CENTENNIAL PARK

MASTER PLAN UPDATE

Preferred Design Options Survey Summary Report

December 9, 2020

Sports Fields: Location and Layout

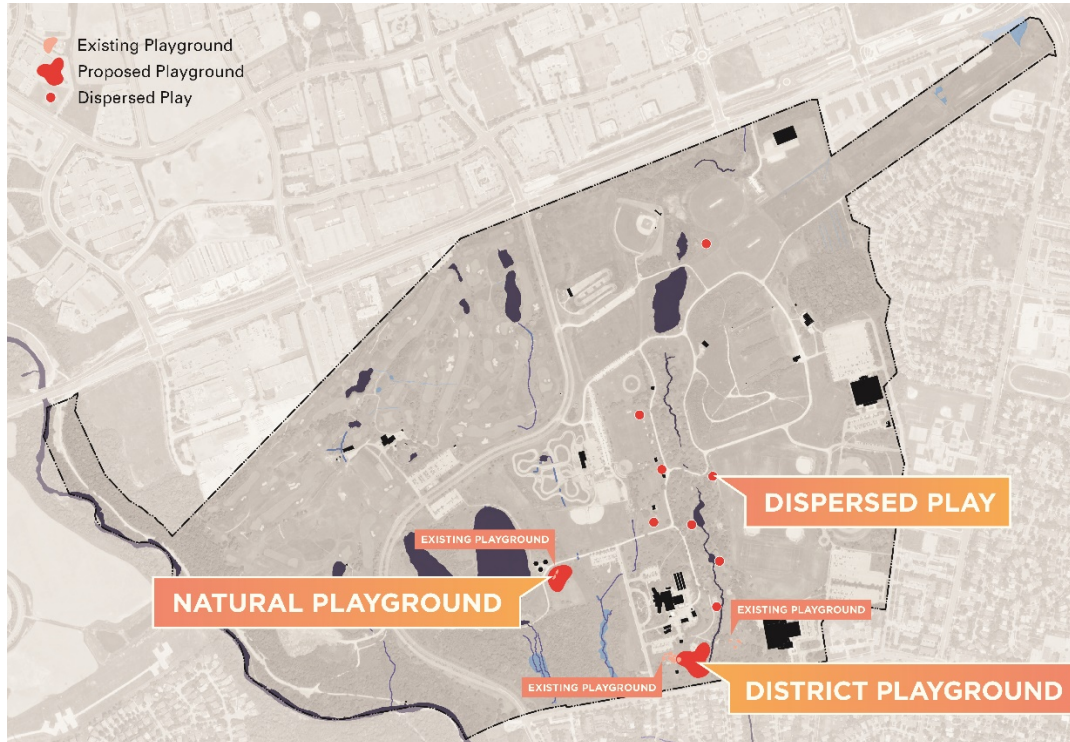
78% of survey respondents agreed with the proposed layout of the **Sports Facilities**

- Basketball:
 - Interested in including more basketball courts (33)
 - Disagreed with the spatial orientation of the basketball courts (safety, noise, etc.) (6)
- Go-Karts:
 - Disagreed with the elimination of the go-karts (21)
- Skating:
 - Interested in the inclusion of winter skating (17)
- Soccer:
 - Indicated there are too many soccer fields (15)
- Tennis:
 - Interested in including more tennis courts (14)
- Pre-Existing:
 - Interested in maintaining the park as is (11)
- Volleyball:
 - Interested in the addition of volleyball courts (6)
- Dog park:
 - Interested in the inclusion of a dog off-leash area (6)

- Skiing:
 - Interested in maintaining the current ski hill (5)
- Nature:
 - Interested in maintaining the park as natural as possible (5)
- Baseball:
 - Disagreed with the reduction of one baseball diamond (4)
 - Disagreed the position of the baseball diamonds (safety) (3)
 - Interested in removing further baseball diamonds (1)
- Softball:
 - Disagreed with the reduction of three softball diamonds (4)
- Curling:
 - Interested in including curling facilities in the park (4)
- Swimming:
 - Interested in including an outdoor swimming pool (4)
- Cost:

- Interested in keeping the park as low cost as possible (4)
- Trails:
 - Interested in including more trails throughout the park (4)
- Cricket:
 - Disagreed with the additional cricket pitch (3)
 - Interested in including more space for the additional cricket pitch (1)
- Seniors:
 - Interested in including considerations for senior's activities (3)
- Cycling:
 - Interested in including more designated cycling trails/lanes (3)
- BMX:
 - Interested in maintaining the BMX track in the park (3)
- Track and Field:
 - Interested in maintaining track and field facility (3)

- Fitness:
 - Interested in including a fitness area within the sports fields (2)
- Football:
 - Interested in including football and Gaelic football fields (2)
- Parking:
 - Interested in more parking (2)
 - Indicated that more parking is not needed (1)
- Disc Golf:
 - Interested in clearer location / enhanced wayfinding for disc golf (2)
 - Indicated that the location of disc golf is intrusive (1)
 - Indicated that disc golf cages are not necessary (1)
- Archery:
 - Interested in including an archery center (1)
- Fishing:
 - Interested in fishing supplies for the pond (1)
- Flying circle:
 - Indicated that the flying circle is unnecessary (1)
- Pickle Ball:
 - Interested in including pickle ball (1)
- Skate park:
 - Disagreed with the skate park (1)
- Splash Pad:
 - Interested in a splash pad for children (1)
- Accessibility:
 - Interested in seeing more accessible areas (1)

Play

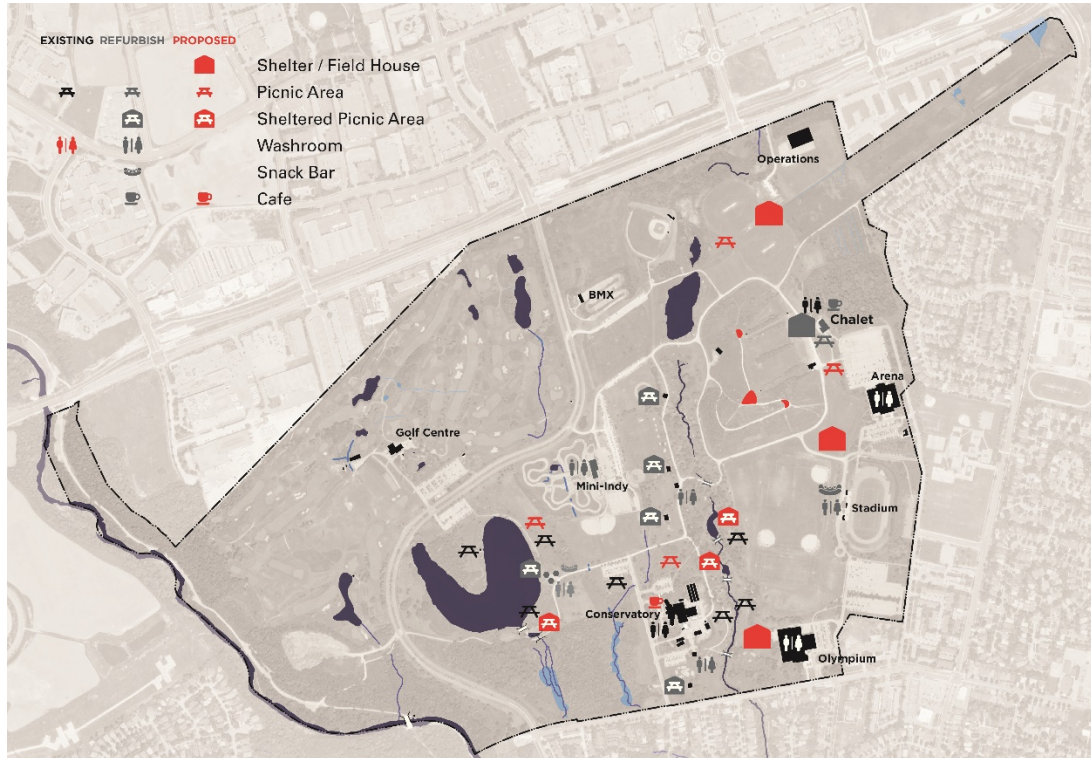
91% of survey respondents agreed with the proposed sitting of the **Natural Playground**

88% of survey respondents agreed with the proposed sitting of the **District Playground**

88% of survey respondents agreed with the proposed sitting of the **Dispersed Play**

- Play Location:
 - Interested in spreading out the play areas (5)
 - Indicated that the district playground should be moved to the centre of the park (3)

- Interested in more parking near the district playground (2)
 - Indicated that the district playground should not be by the ravine for safety (1)
 - Interested in separating play features from picnicking areas (1)

- Indicated that there should be more play near sports fields (1)
- Splash Pad:
 - Interested in seeing more water play and splash pads for kids (5)
- Dispersed:

- Indicated that the spatial organization of the dispersed play is a safety hazard (sports fields, disc golf, etc.) (4)
- Toboggan:
 - Interested in maintaining the toboggan hill (4)

- Playgrounds:
 - Indicated that there should be more areas for play (3)
 - Indicated that dispersed play should be the only play areas (2)
 - Indicated that the district playground should be the only playground (1)

- Natural Play:
 - Interested in increasing the amount of natural play areas (3)
 - Indicated that the spreading out of natural play is not practical for parents (1)

- Cost: Indicated that the play areas are not worth the cost to the City (2)
- Pre-existing: Interested in maintaining the existing play features (2)
- Interference: Indicated that the play areas intersect bike paths creating safety concerns (1)
- Go-Karting: Interested in maintaining the go-karting facilities (1)
- Golf: Interested in reallocating the golf course (1)
- Accessibility: Interested in the location of play areas and accessibility challenges (1)

- Ski Hill:
 - Interested in more play areas near the ski hill (11)
- Directional:
 - Interested in more play areas in the North and West areas of the park (6)
 - Interested in more play areas in the South East area of the park (1)
 - Interested in a play area near Hollycrest (1)
- Sports fields:
 - Interested in more play areas by the sports fields (5)
- Pond:
 - Interested in more play areas near the pond (4)
- Dog Park:
 - Interested in a dog park for animal play (3)

- Residential: Interested in more play areas near residential areas of the park (2)
- Splash pad: Interested in a better splash pad (2)
- BMX: Interested in a play area near the BMX track (1)
- Cricket: Interested in a play area near the cricket fields (1)
- Disc Golf: Indicated safety concerns for play areas near disc golf (1)
- Skatepark: Interested in the inclusion of a skatepark (1)
- Benches: Interested in more benches and shelter near the play areas (1)
- Walking path: Indicated that play areas should be separated from walking/biking paths (1)
- Accessibility: Interested in the location of play areas and accessibility challenges (1)

Structures

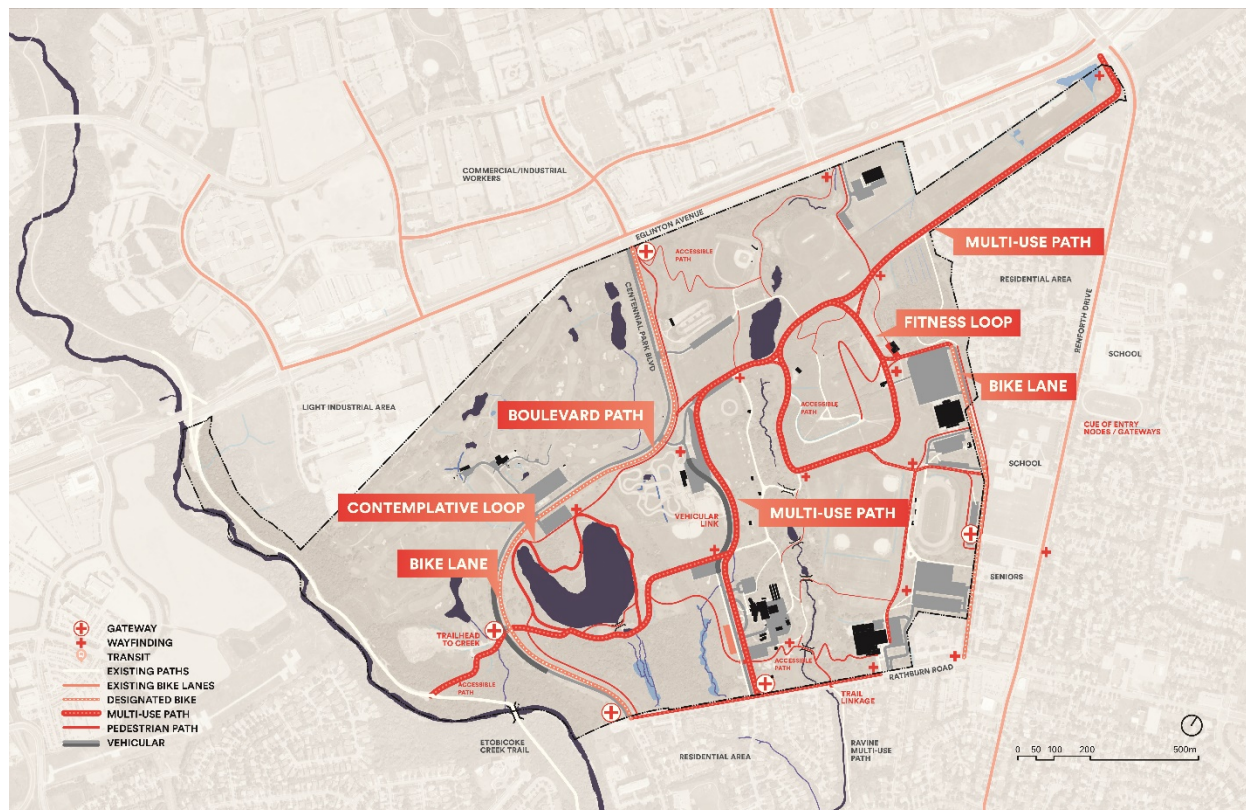
90% of survey respondents agreed with the proposed location of **Cafe**

88% of survey respondents agreed with the proposed **Picnic Sites**

87% of survey respondents agreed with the proposed **Shelters**

- Café Location:
 - Disagreed with the addition of a café to the park (10)
 - Interested in a café near the stadium (4)
 - Interested in a café near the ski hill (3)

- Interested in a café at the conservatory (2)
- Nature:
 - Interested in least number of structures to keep the park as natural as possible (10)
- Shelter Location:

- Interested in spreading out and increasing the number of shelters (6)
 - Disagreed with the additional shelters (5)
 - Disagreed with a shelter near the pond (4)

- Interested in least number of shelters near the sports fields (2)
- Picnic Location:
 - Disagreed with the additional picnic areas (4)
 - Disagreed with a picnic area near the pond (4)

- Interested in more picnic areas near the sports fields (3)
 - Interested in picnic areas near the base of the ski hill (2)
 - Interested in picnic areas near larger trees instead of creating shelters (1)

- Disagreed with picnic areas near the chalet (1)
 - Interested in separating picnic areas and disc golf course (1)
- Restaurant:
 - Interested in the addition of a restaurant (4)

- Noise: Interested in least number of shelters near residences to decrease noise (3)
- Seating: Interested in more areas for seating (2)
- Spacing: Interested in more structures on the West end of the park (1)

- Washrooms:
 - Interested in increasing the general number of washrooms (15)
 - Interested in increasing the number of washrooms:
 - Near the BMX facility (10)
 - Near the pond (3)
 - Near picnic areas (2)
 - Near the sports fields (2)
 - Near the golf course (1)
- Picnic Location:
 - Interested in increasing picnic areas by the golf course/pond (5)
 - Interested in increasing the number of picnic tables (4)
- Shelters:
 - Interested in increasing the general number of shelters (5)
 - Interested in increasing the number of shelters:
 - Near the sports fields (2)
 - On the south side (1)
 - Near the playground (1)
 - By the pond (1)
- Café Location:
 - Interested in a café near the ski chalet (4)
 - Interested in an additional café (4)

- Drinking Fountains: Interested in increasing number of drinking fountains (2)
- Nature: Interested in decreasing number of structures to keep the park as natural as possible (2)
- Garbage: Interested in increasing number waste disposal options (1)

Movement

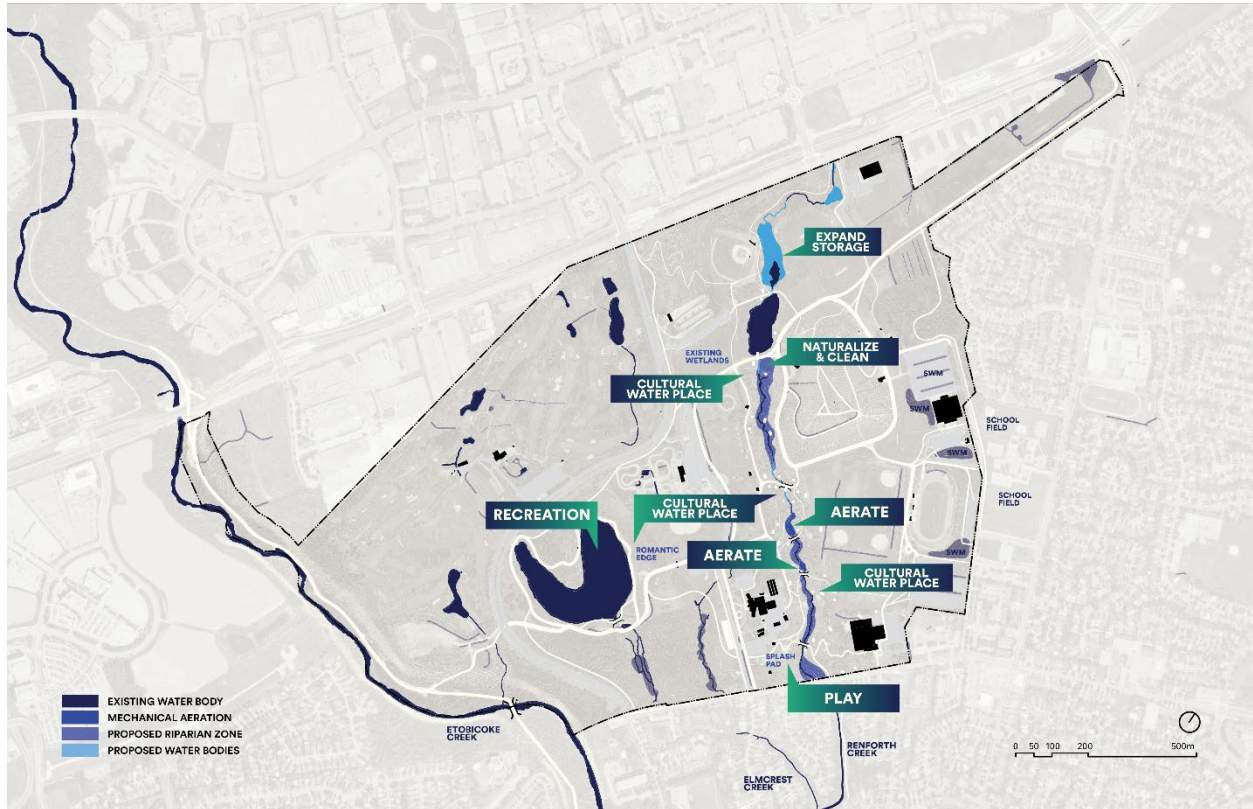
93% of survey respondents agreed with the layout of the proposed **circulation features**

- Bike Paths:
 - Interested in separating bike lanes and pedestrian paths (8)
 - Interested in increasing the number of bike lanes (1)
- Nature:
 - Interested in increasing maintaining the park as natural as possible (5)
- Pedestrian Paths:
 - Interested in paved pathways for walkers (3)
 - Interested in lengthening/increasing pedestrian pathways (2)

- Interested in removing the pathway on the ski hill (2)

- Map: Interested in including wayfinding and maps along trails (2)
- Car Traffic: Interested in decreasing the volume of car traffic through the park (2)
- Activity: Interested in decreasing the amount of activity in the park (1)
- Accessibility: Interested in mapping /visualizing the accessible paths (1)

- Pedestrian Paths:
 - Interested in increasing the number of pathways (6)
 - Interested in a trail loop around the entire park (4)
 - Interested in a more direct paths to sport facilities (3)
 - Interested in varying the trail difficulty for different uses (1)
- Accessible:
 - Interested in paving pathways for better accessibility (6)
 - Interested in ensuring the pathways are accessible from all entrances and roadways (3)
 - Interested in ramps on high curbs to support wheel mobility (1)
- Map:
 - Interested in wayfinding, signage and maps throughout the trails (6)
- Bike Paths:
 - Interested in separating bike lanes and pedestrian paths (5)
 - Interested in a separated bike path on Centennial Park Blvd. (2)
 - Interested in transforming paths into cross-country skiing trails during the winter (1)
- Safety:
 - Interested in sidewalks and crosswalks along the main roads (5)

- Disc Golf: Indicated that circulation network should avoid crossing the disc golf course (1)
- Car Traffic: Interested in preventing traffic flow to Eglinton Ave. (1)
- Fitness: Interested in fitness stations along trails (1)
- Indoor trails: Interested in an indoor walking track for winter use (1)
- Mountain Biking: Interested in additional mountain bike trails (1)

Water

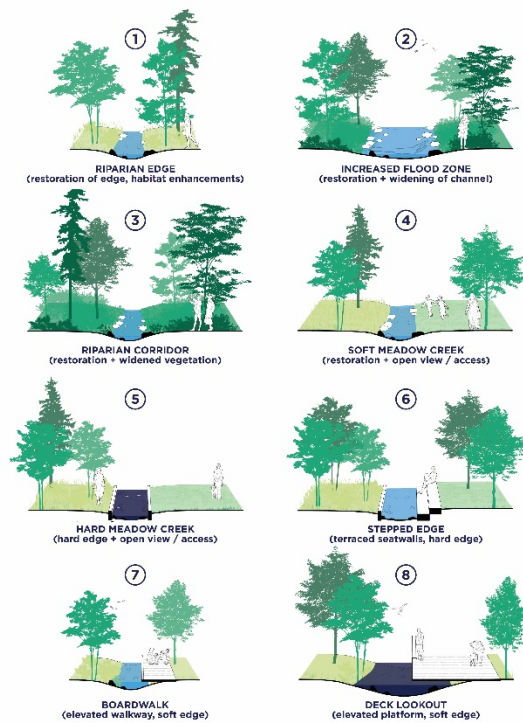
95% of survey respondents agreed with the proposed location of **water uses**.

- Pond:
 - Indicated that the pond needs to have better cleaning systems (5)
 - Disagreed with the pond used for recreation (3)
 - Interested in seeing a dock for non-motorized boats (1)
 - Interested in ice skating on the pond (1)
- Cultural
 - Indicated that they do not understand the concept of “cultural water place” (4)
- Water Play
 - Interested in seeing a new splash pad (3)
 - Interested in adding an additional splash pad (3)
 - Interested in introducing more natural water areas for play (1)

- General: Interested in increasing the amount of water features (2)
- Drinking Fountain: Interested in including more drinking fountains around the park (1)
